<b>Docket Number:</b>	18-IRP-01
<b>Project Title:</b>	Integrated Resource Plan
<b>TN #:</b>	229779
<b>Document Title:</b>	Revised - Staff Paper - Review of San Francisco Public Utilities Commission's Integrated Resource Plan Filing
<b>Description:</b>	N/A
<b>Filer:</b>	Courtney Wagner
<b>Organization:</b>	California Energy Commission
<b>Submitter Role:</b>	Commission Staff
<b>Submission Date:</b>	9/18/2019 4:07:46 PM
<b>Docketed Date:</b>	9/18/2019

# **Review of San Francisco Public Utilities Commission's Integrated Resource Plan Filing**

June 2019 | CEC-200-2019-007

**Figure 1** compares the SFPUC’s 2017 IRP baseline energy demand forecast for 2019 to 2030 to forecasts adopted by the CEC as part of the *2017 Integrated Energy Policy Report (IEPR)*.

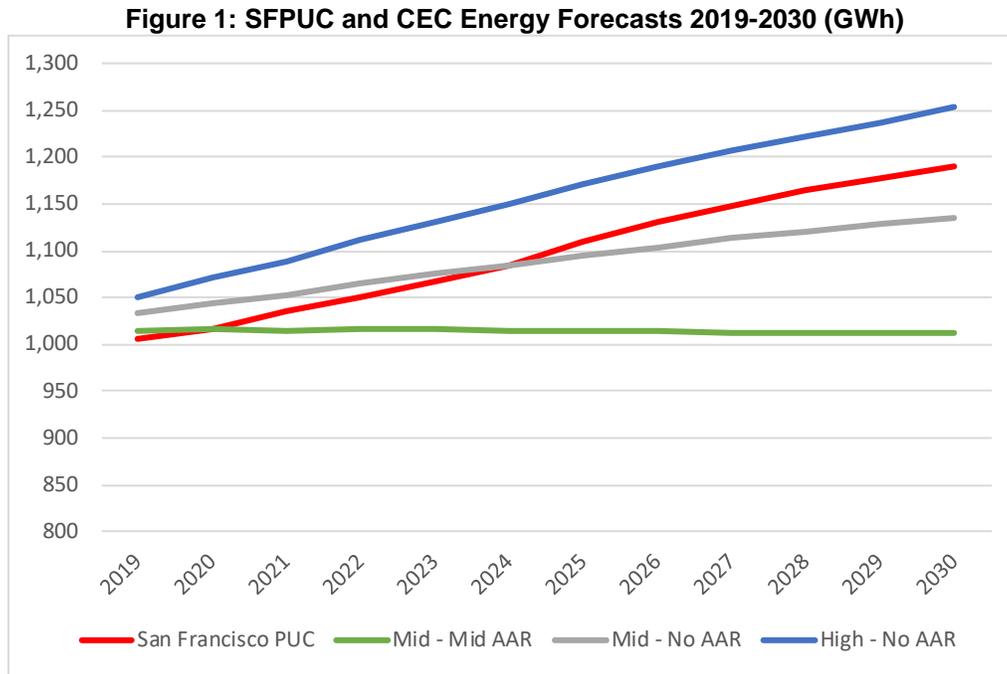
The SFPUC projected annual growth over 2019 to 2030 of slightly more than 1.5 percent, while the CEC’s “mid demand, mid additional achievable resources” forecast shows no growth.<sup>9</sup> The annual growth rate projected by the SFPUC is comparable to the CEC’s “high demand, no additional achievable resources” scenario of 1.6 percent.

The CEC’s forecasts of the SFPUC’s energy demand growth, because of its small size (less than a 200-MW peak demand), are based on a growth rate for the Pacific Gas and Electric (PG&E) planning area, which is driven largely by assumptions regarding demographics and the economy. Most of the SFPUC retail sales are to municipal departments, whose demand is less influenced by changes in economic conditions and demographics than are residential, commercial, and industrial consumption. Consequently, the utility used information from the city’s long-term capital planning process to forecast demand growth arising from “new” municipal customers. Capital investments on the part of the city that increase its energy needs place less emphasis on

A comparison of the peak demand forecast in the IRP filing to the 2017 IEPR forecasts is in Figure 2.

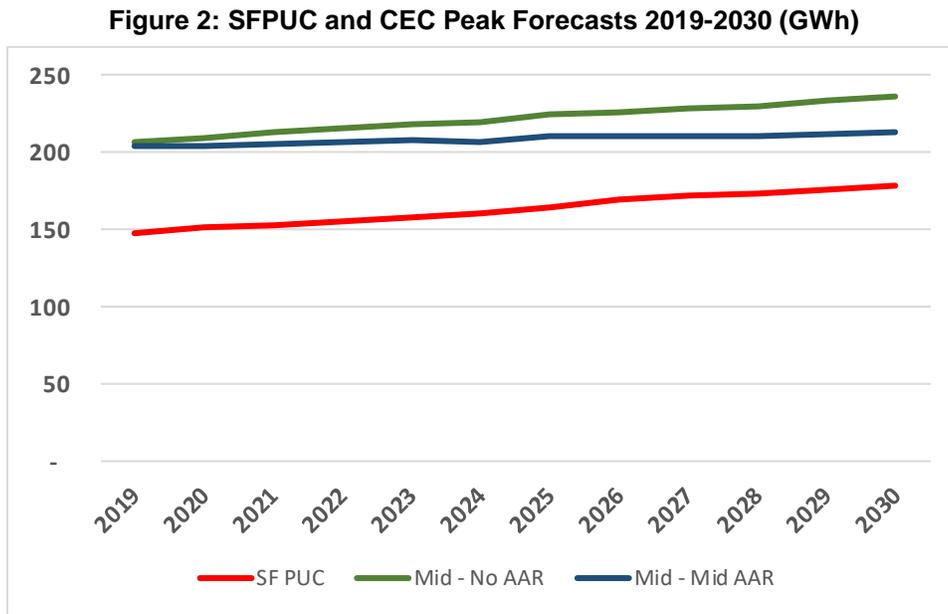
The CEC's forecasts are well above that of the SFPUC's forecasts. The difference in peak forecasts may be attributable to how the PG&E planning area forecast is shared with the SFPUC forecast. The CEC indirectly forecasts the SFPUC peak demand by apportioning a share of the PG&E planning area peak forecast to the SFPUC service territory.
